Report No. 10CFR21-0133

**10CFR21 REPORTING OF DEFECTS
AND NON-COMPLIANCE**

COMPONENT: Swing Check Valve, P/N ESI50359

SYSTEM: Emergency Diesel Generator

Figures 1 & 2: View of Swing Check Valve P/N ESI50359

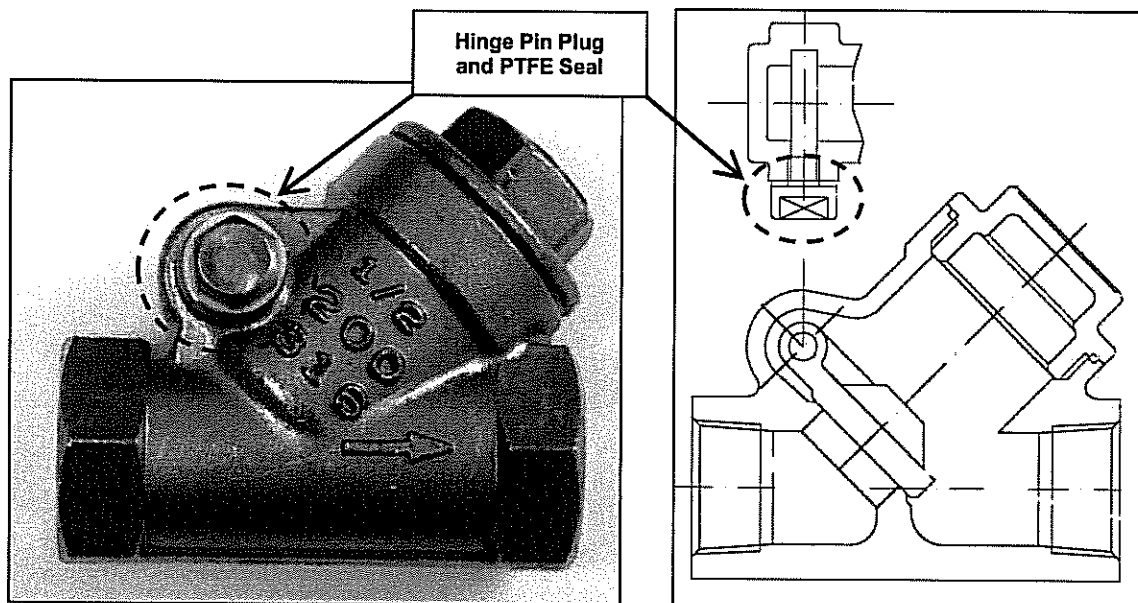
The hinge pin retainer plug used on check valve P/N ESI50359 may exhibit low breakaway torque and thus minimal resistance to loosening when subjected to engine operating vibrations. Consequently, if the plug were to completely dislodge, followed by the associated hinge pin, the pressure boundary of the lube oil system would be compromised and oil would discharge through the 3/16" diameter opening. ESI was notified by a nuclear customer of such an occurrence on a check valve that had been recently installed. Following notification, ESI inspected remaining check valves in inventory and confirmed an issue where the plug exhibited low breakaway torque that could potentially lead to unintended loosening.

P/N ESI50359 is a 1/2" female NPT, stainless steel swing check valve used specifically for EMD engine applications in the gallery fill line between the lube oil cooler and main engine pressure pump discharge elbow. During standby conditions, the valve allows forward flow of heated lube oil to the engine. During engine operation, the valve closes to prevent reverse flow of main lube oil. The plug retains the hinge pin within the valve and utilizes straight threads, thus requiring a sealing washer. The material of the sealing washer is PTFE. Due to the relatively soft nature of the PTFE and small surface area, the applied torque must be minimized to prevent deformation or extrusion. These factors, in conjunction with the relatively low friction coefficient of PTFE, lead to a low breakaway torque and the potential for loosening. See Figure 1 & 2 below for a visual depiction of the swing check valve. Figure 3 on the following page shows a typical installation.

ESI recommends a rework of the check valve. Remove the hinge pin retainer plug and ensure plug threads and PTFE washer are free from damage or distortion. Apply Loctite 243 sparingly to clean plug threads then re-install the plug and PTFE washer, using caution to minimize seepage of thread locker. Using a 10mm socket, torque the plug to 5 (± 0.5) in-lbs and allow the Loctite to cure.
